BEACON PLANNING BOARD
Via Video-Conference
BEACON, NEW YORK 12508
Phone (845) 838-5002 Fax (845) 838-5026

Conklin Street - Beacon Views

Continue public hearing for SEQRA environmental review on applications for Subdivision and Site Plan Approval, "Beacon Views Townhouses" 39 units, Conklin Street, submitted by Beacon Views, LLC

RE: Beacon Views Site Plan and Conservation Subdivision
Conklin Street
Beacon, New York
Tax Parcel ID: 6055-03-331123

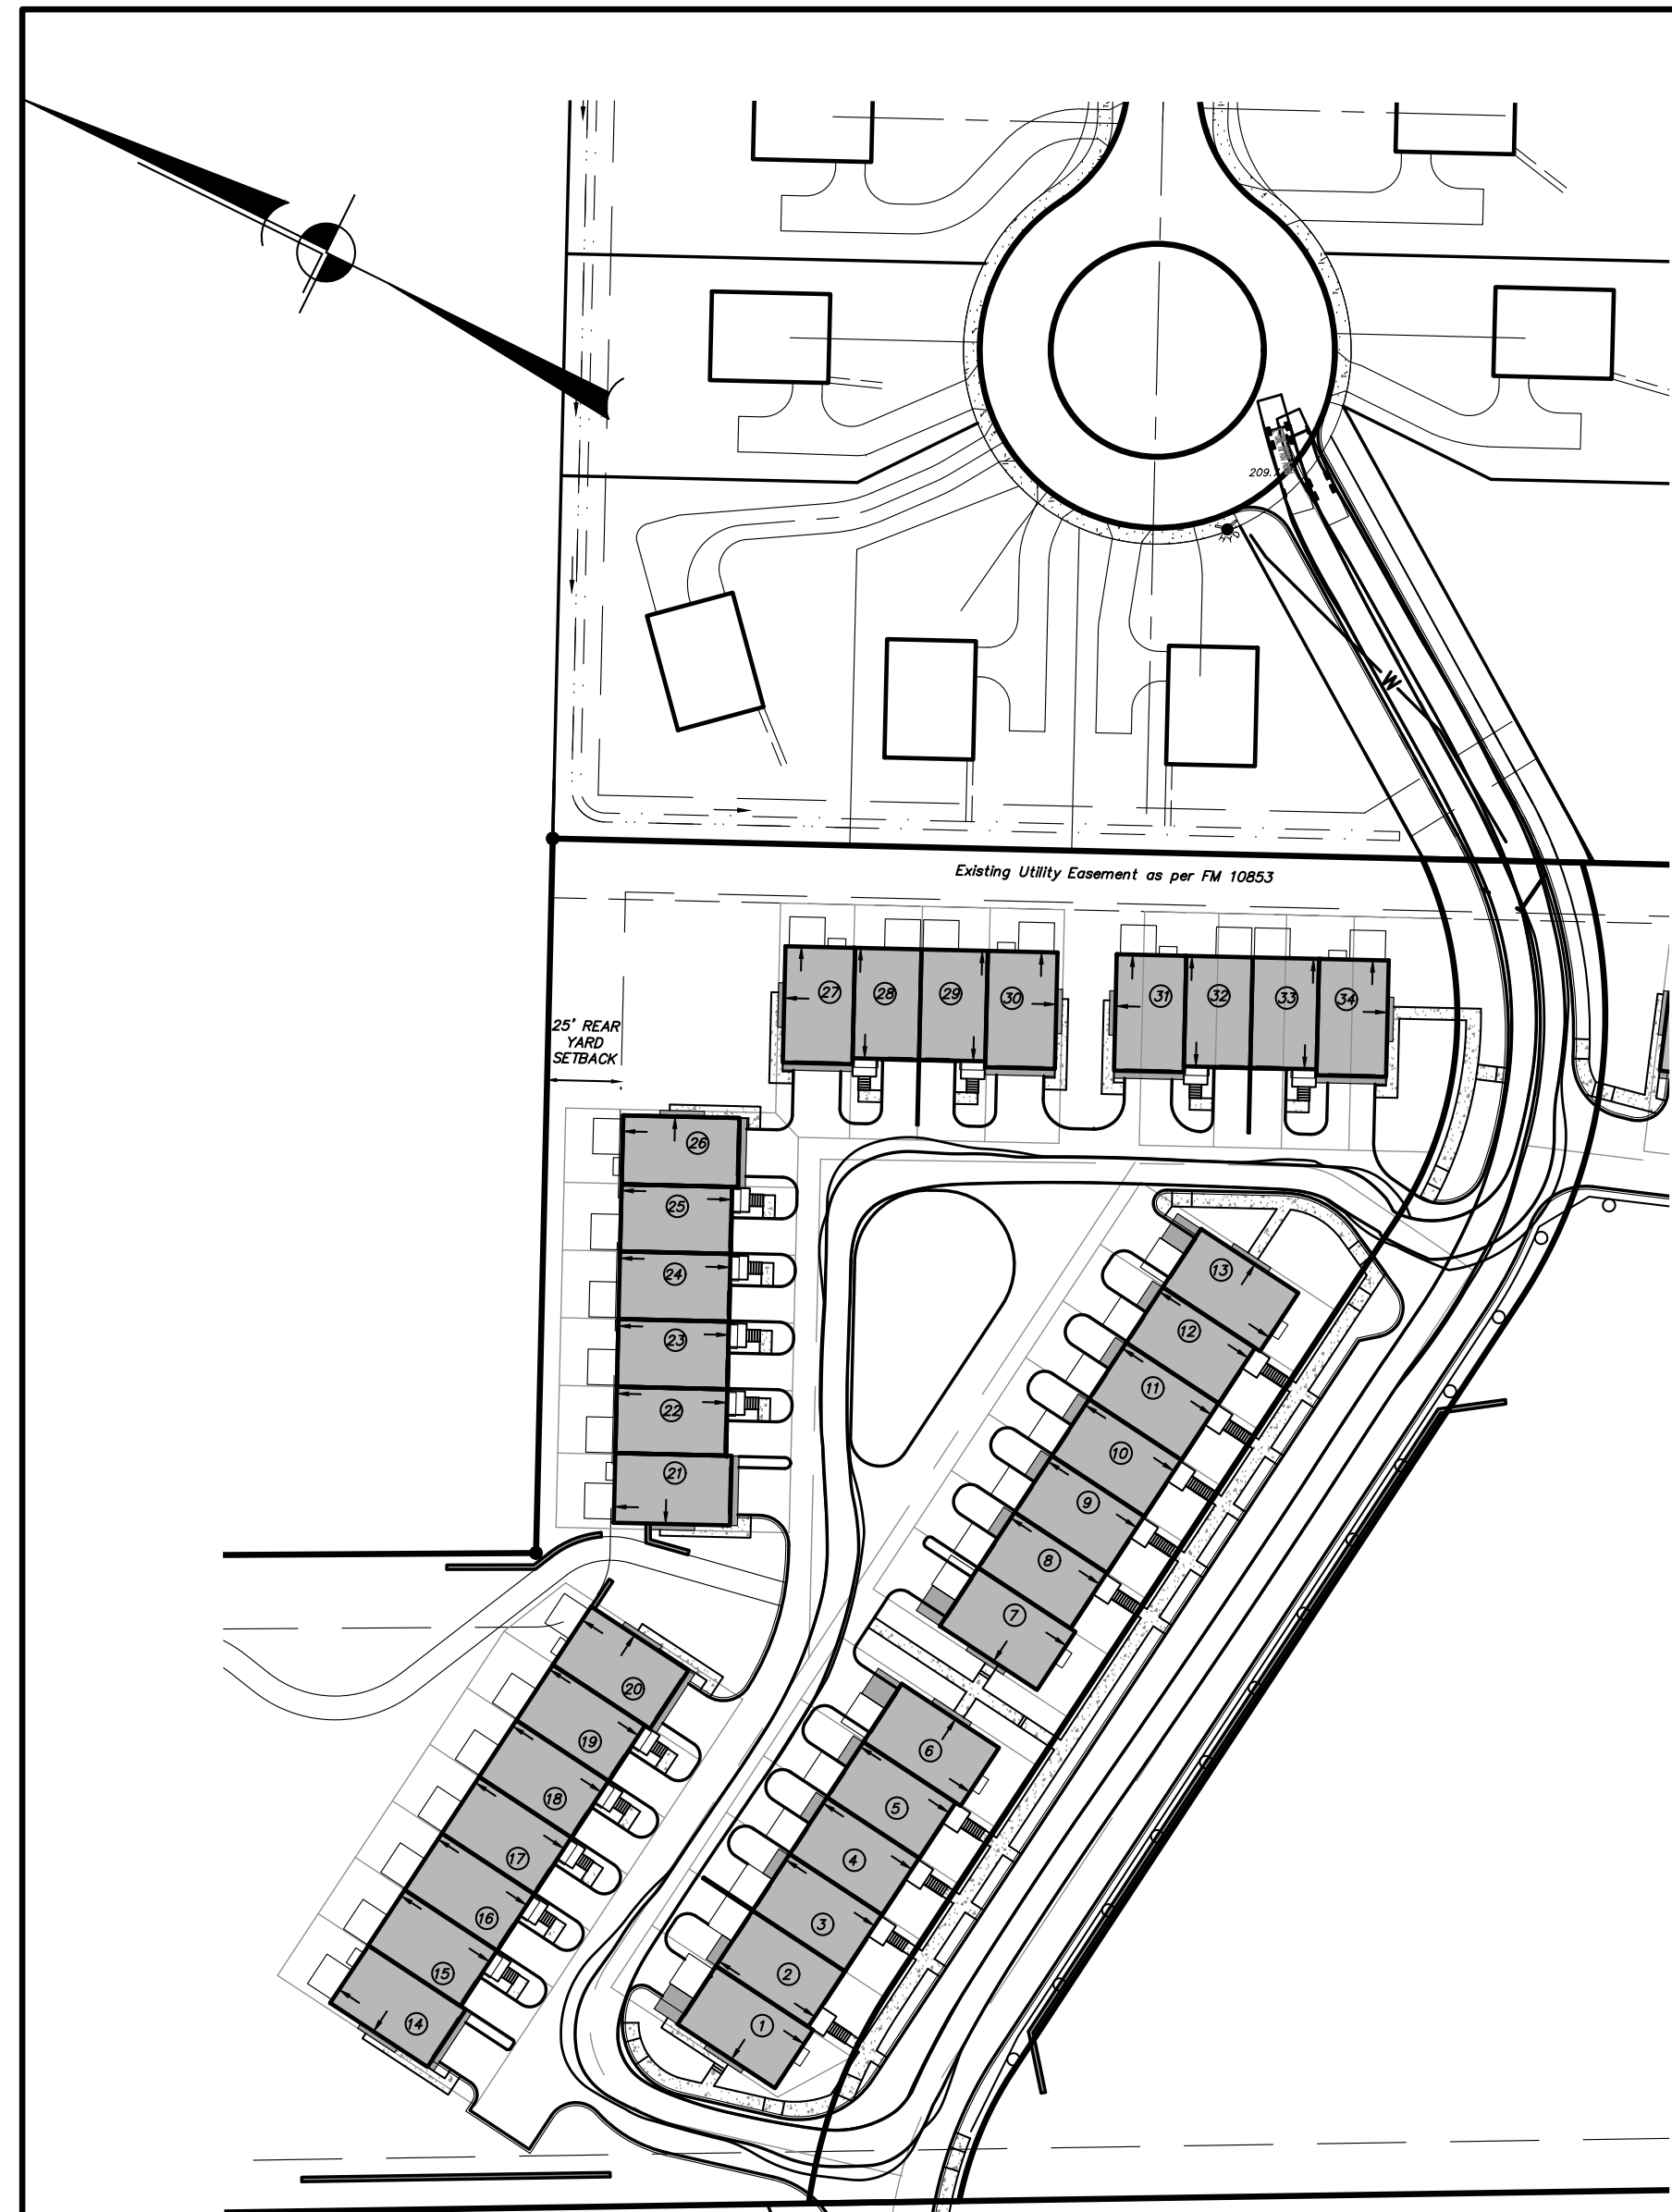
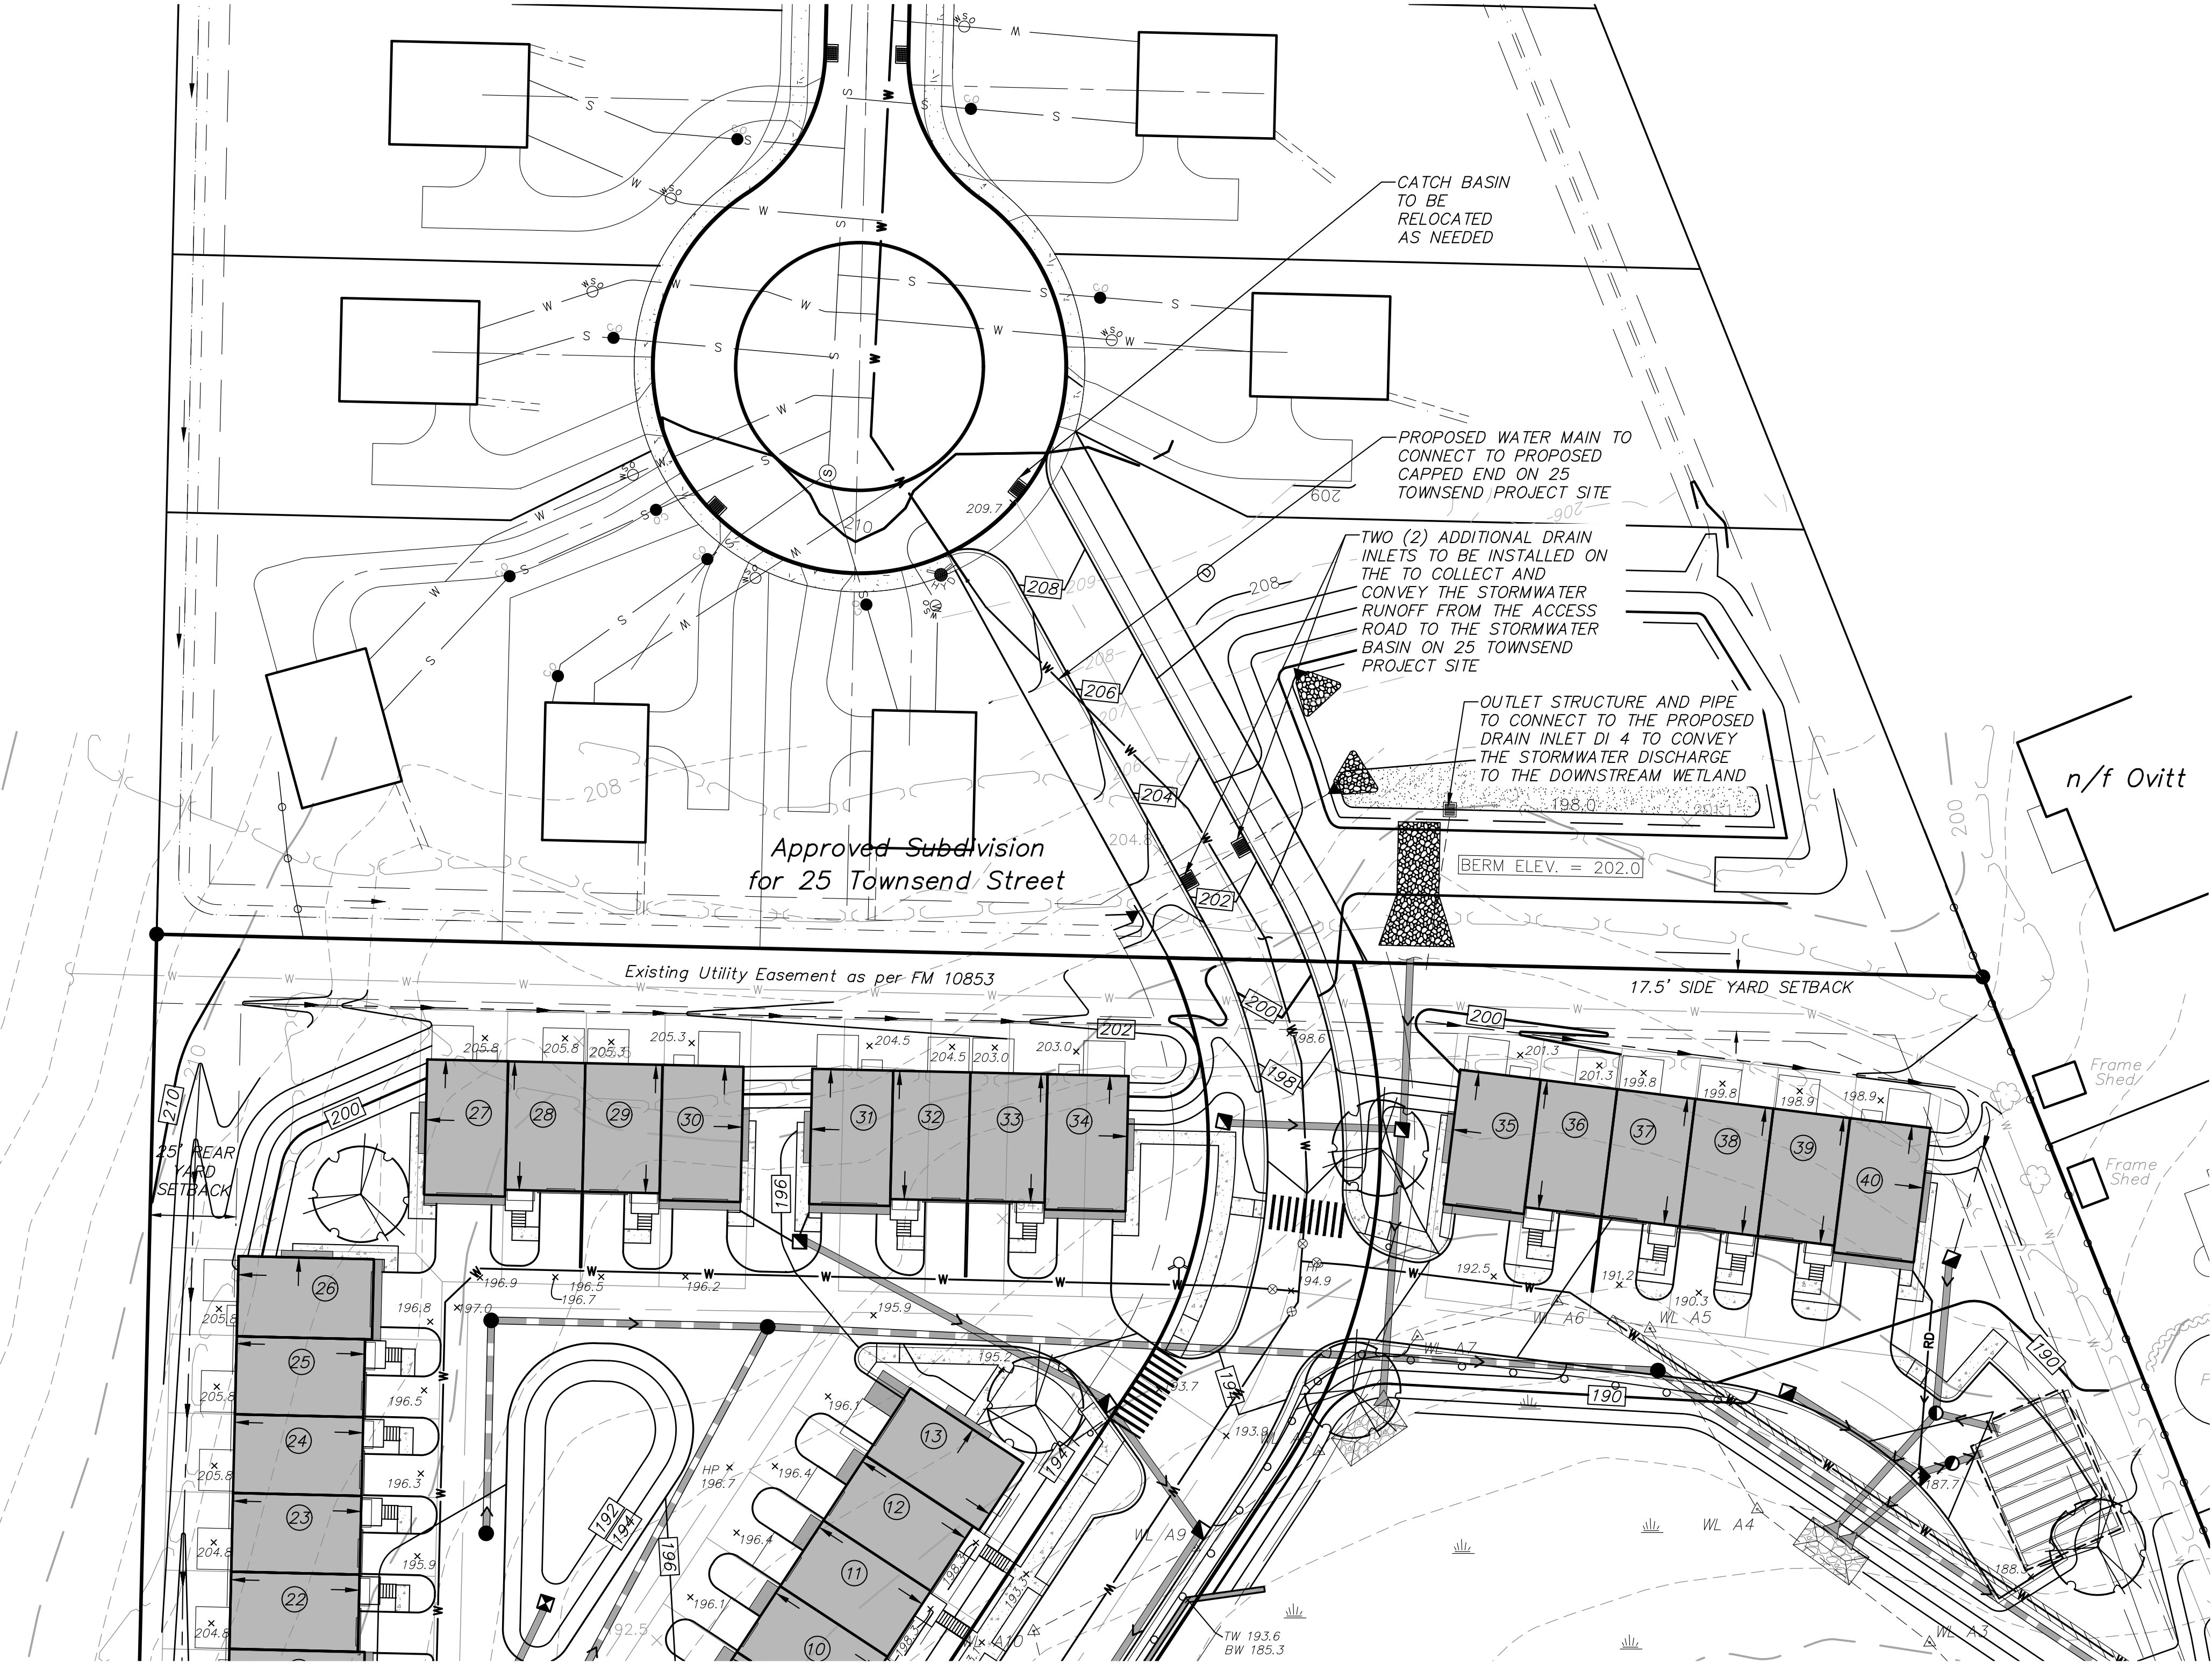
3. Fire truck maneuvers have been included on sheet SP-4. The specifications of the truck depicted in the plan is similar in dimensions and turning radius to the vehicle that the Fire Department has provided as their largest vehicle.

2. A Site Access Plan (SP-4) has been added to the set to illustrate the proposed connection to the 25 Townsend cul-de-sac, and associated improvements. A plan for the improvements to the Highland Meadows Senior Housing property, as required by the Easement agreement, will be developed as discussions with the property owner goes forward.

LIGHT POLE BASE DETAIL
(N.T.S.)

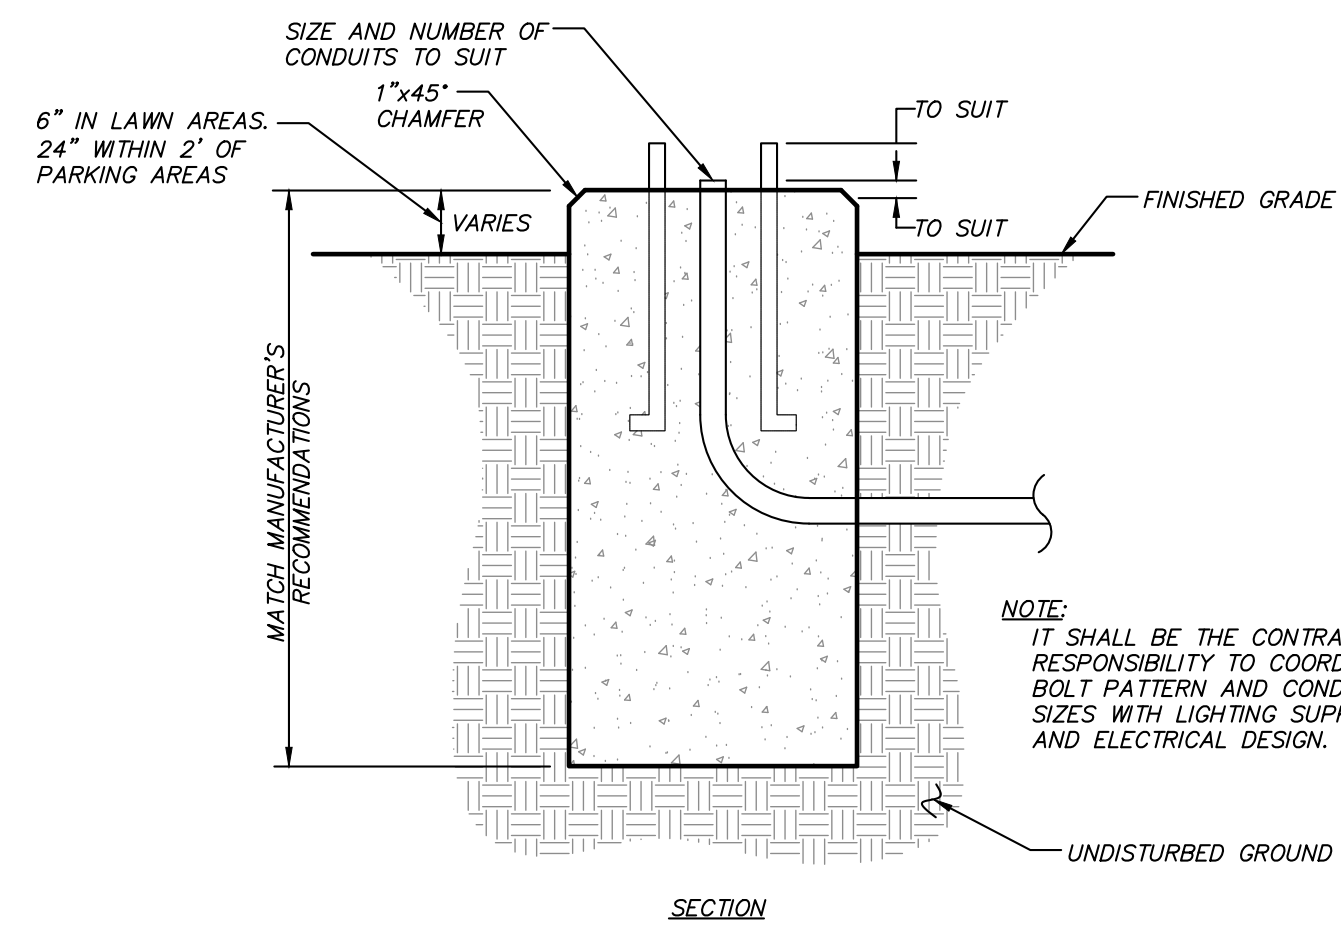
2. The diameter of the light pole base has been indicated in the detail.
3. The sidewalk detail has been revised as requested.
4. The size of the wire mesh has been indicated in the sidewalk detail.
